Service Letter No. 477

SUBJECT: F.A.A. Airworthiness Directive No. 66-12-2 issued May 3, 1966 (temporary revision to airspeed limits)

MODELS AFFECTED: PA-30 Twin Comanches, Serial Nos. 30-1 to 30-852 incl., 30-854 to 30-901 incl.

PROCEDURE FOR BALANCING THE STABILATOR

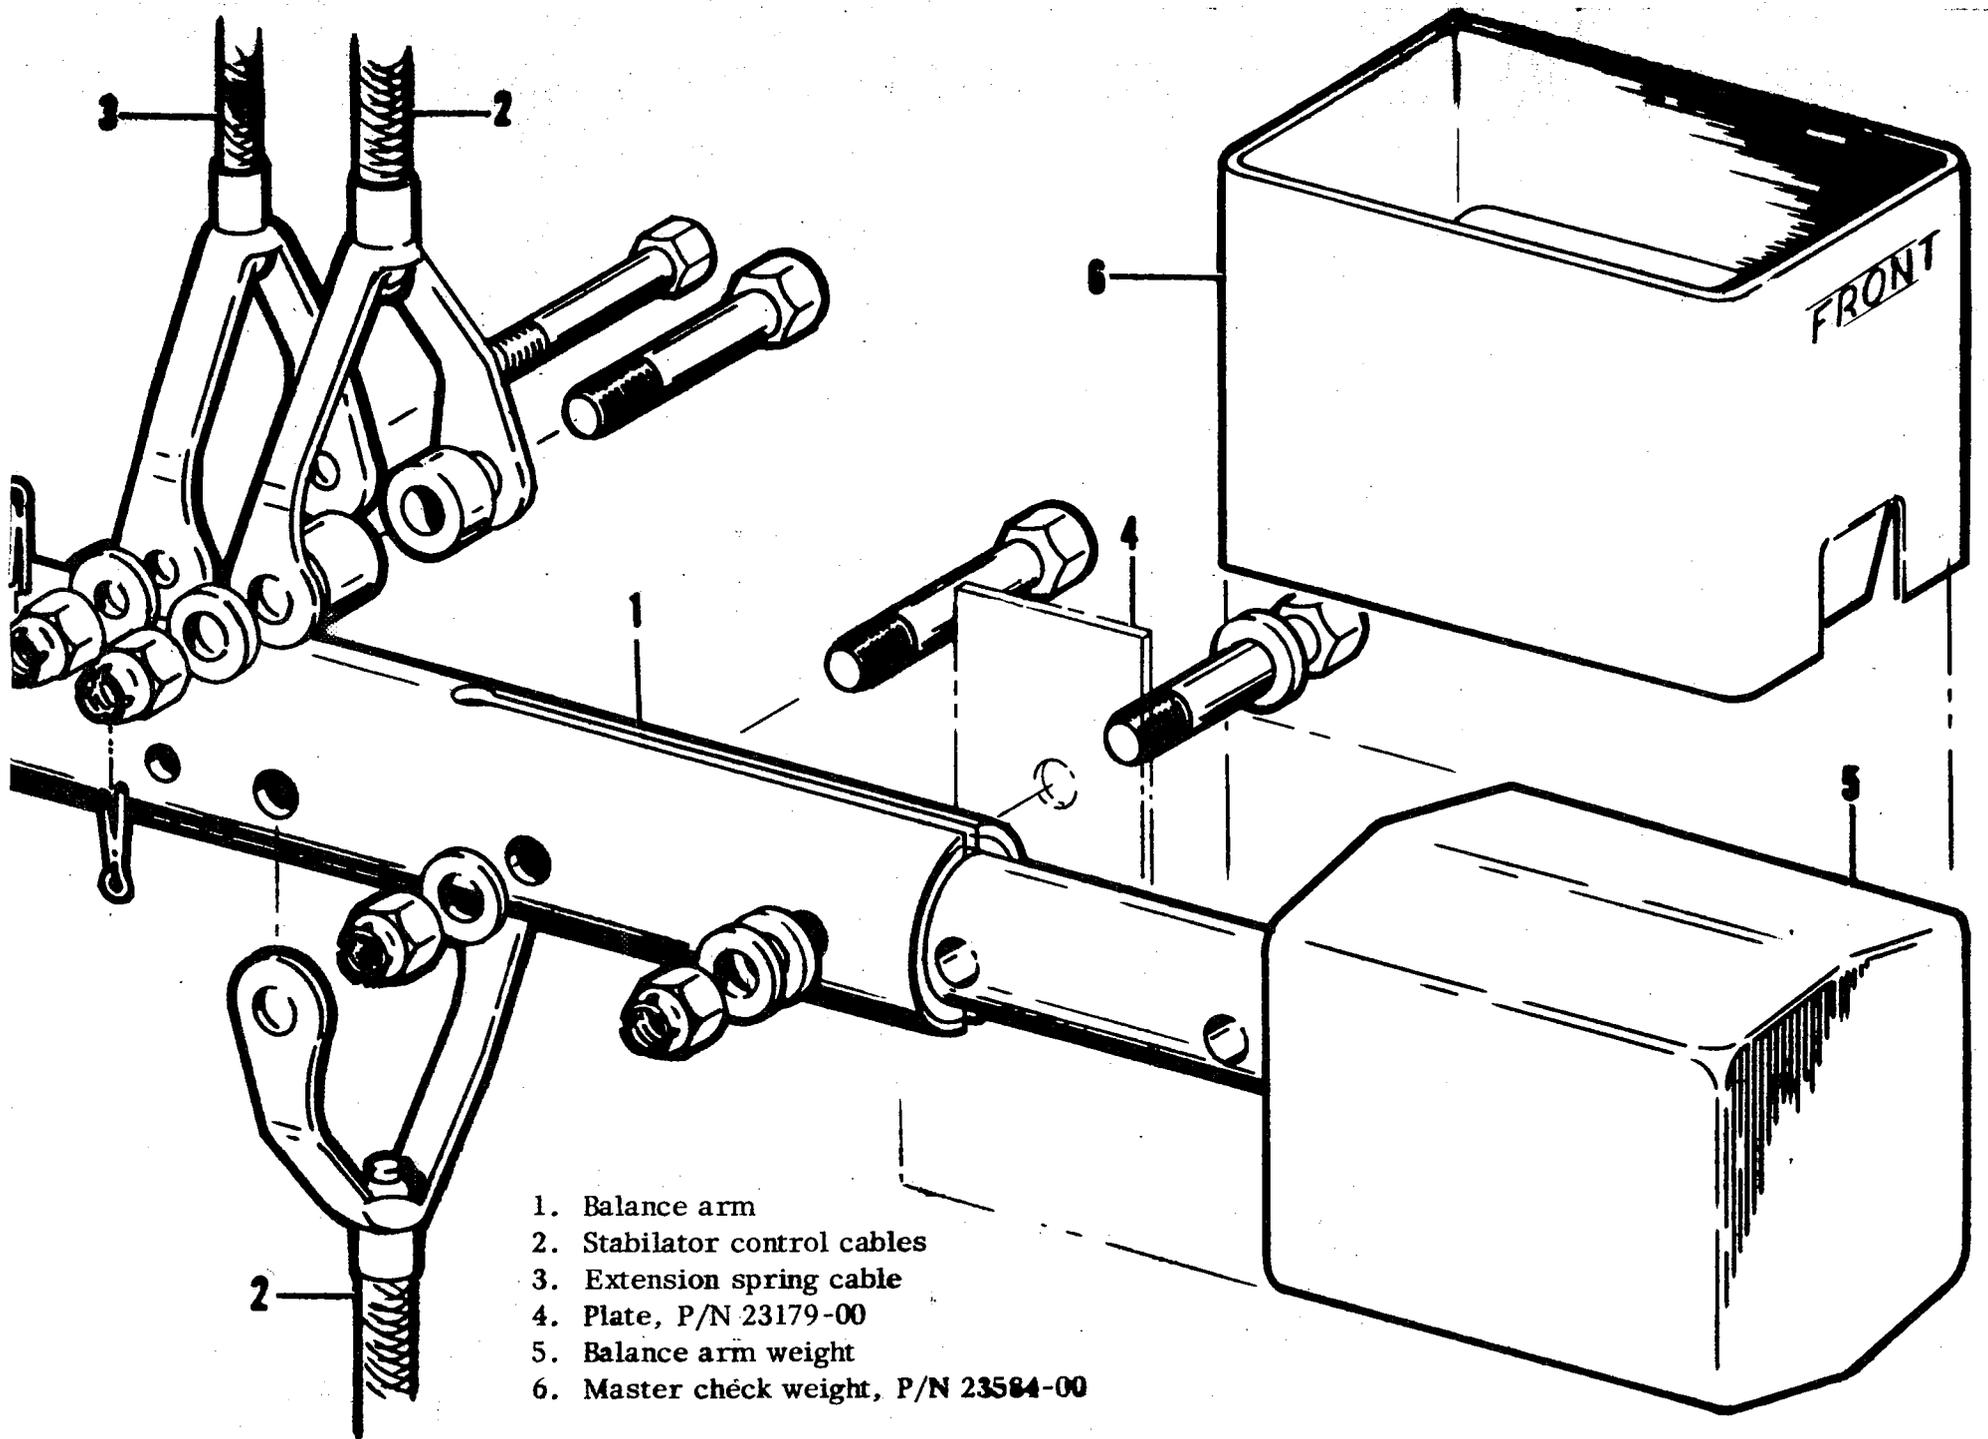
If during the service life of the airplane alterations or repairs were made to the stabilator or the stabilator trim tab the stabilator must be rebalanced immediately in accordance with the instructions and sketch attached to this letter.

c. Master check weight 23584-00 (weight 1.58 pounds) should be placed on top of balance weight 23594-00 with the side marked "FRONT" facing forward. If this is not enough weight to obtain static balance with the balance arm level, plates 23179-00 must be added to the forward balance weight attachment bolt until 100% static balance is obtained or until up to two plates more than that required for **balance** have been added. It should never be necessary to use more than eight plates. If a total of more than eight plates is necessary to obtain balance, the manufacturer should be consulted.

d. If it should become necessary in the field to balance a stabilator without a master check weight, a temporary balancing can be accomplished by following the procedure given in "b" above except that instead of using a master check weight a sensitive and accurate fish scale can be used to get a balance with 49 ± 3 inch pounds of torque. Thus plates should be added (up to eight) until a lifting force of between 2.71 and 2.88 pounds will balance the stabilator with the fish scale being hooked to the bolt which fastens the two stabilator-connecting tabs together (arm of 17 inches). As soon as a master check weight is available the balance should be checked for accuracy.

e. After balancing is accomplished, the check weight (or fish scale) should be removed and the plates should be distributed equally on both sides of the stabilator balance tube and the bolt secured.
